North Central Texas
Council of Governments
**Recommended Amendments to the
2024 International Residential Code**
North Central Texas Council of Governments Region

The following sections, paragraphs, and sentences of the *2024 International Residential Code* are hereby amended as follows: Standard type is text from the IRC. Underlined type is text inserted. ~~Lined through type is deleted text from IRC.~~ A double asterisk at the beginning of a section identifies an amendment carried over from the 2021 edition of the code and a triple asterisk identifies a new or revised amendment with the 2024 code.

Fig R327.3

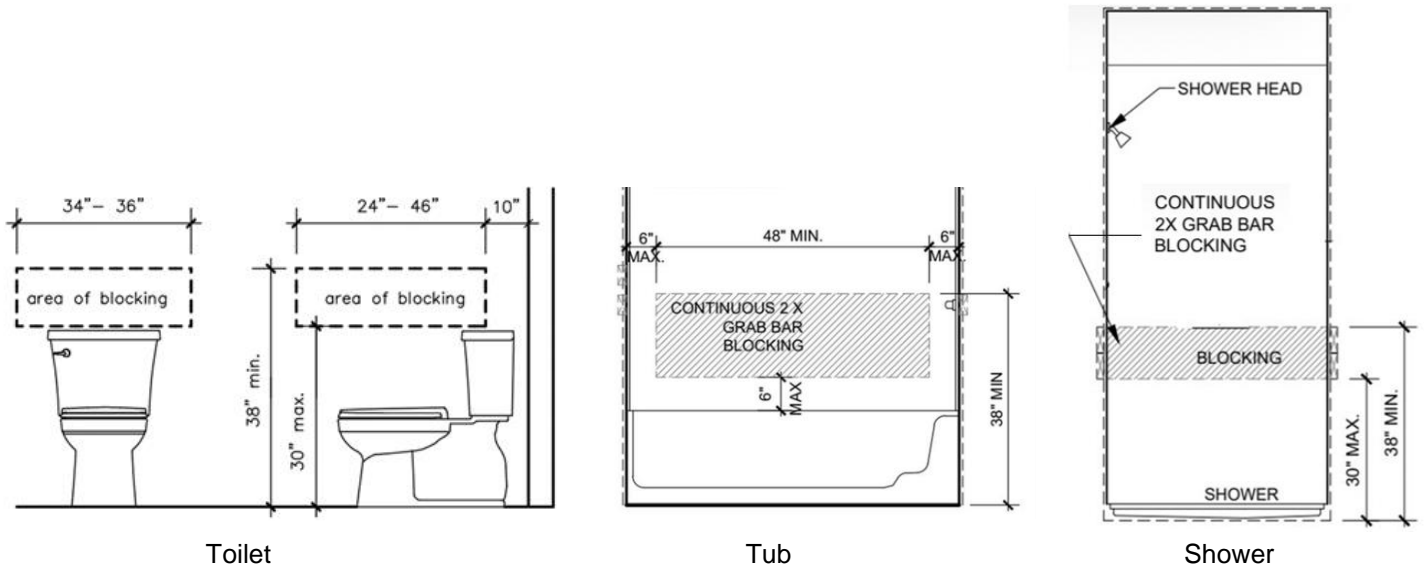
*****R327.3 Blocking Locations; add to read as follows:**

R327.3 Blocking locations. Required at one toilet at grade level with blocking installed at rear wall and, if available, one wall adjacent to toilet and at one tub or shower at grade level. Blocking as shown in Figure R327.3.

(Reason: Blocking at initial construction allows for ease of use for future grab bar installation if desired for homeowners. Ties into Dallas Builders Association of Universal Design Elements concepts for CAPS (Certified Aging in Place Specialists) professionals.)

Fig R327.4

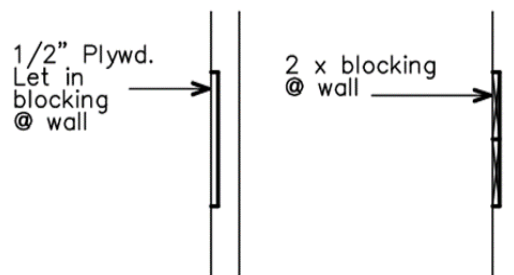
*****R327.4 Wall Blocking; add to read as follows:**

R327.4 Wall Blocking. Blocking may be 1/2" plywood or 2 x solid wood blocking or equivalent, flush with wall as shown in Figure R327.4.

(Reason: Blocking at initial construction allows for ease of use for future grab bar installation if desired for homeowners. Ties into Dallas Builders Association of Universal Design Elements concepts for CAPS (Certified Aging in Place Specialists) professionals.)

****Figure R602.6.1; delete the figure and insert the following figure:**

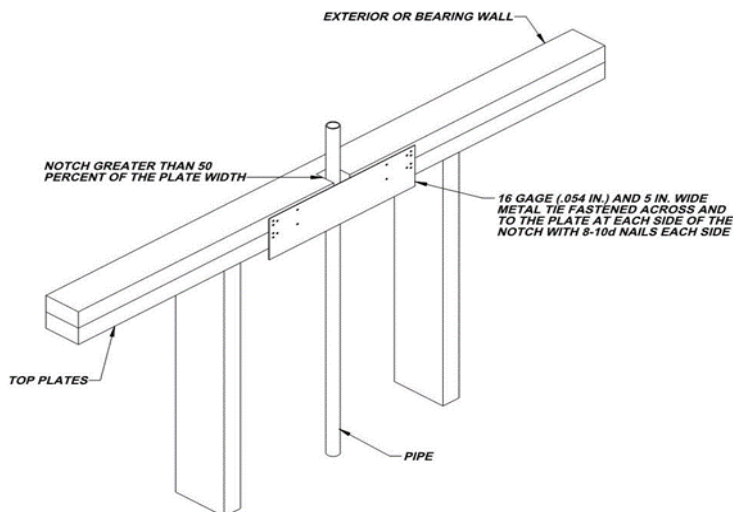
****Section R602.6.1; amend the following:**

R602.6.1 Drilling and notching of top plate. When piping or ductwork is placed in or partly in an exterior wall or interior load-bearing wall, necessitating cutting, drilling or notching of the top plate by more than 50 percent of its width, a galvanized metal tie not less than 0.054 inch thick (1.37 mm) (16 Ga) and ~~4 1/2 inches (38) mm~~ 5 inches (127 mm) wide shall be fastened across and to the plate at each side of the opening with not less than eight 10d (0.148 inch diameter) having a minimum length of 1 1/2 inches (38 mm) at each side or equivalent. Fasteners will be offset to prevent splitting of the top plate material. The metal tie must extend a minimum of 6 inches past the opening. See figure R602.6.1. {remainder unchanged}

(Amendment to 2021 IRC carried forward to 2024 IRC also provides additional assurance of maintaining the integrity of the framing by spreading the nailing pattern.)
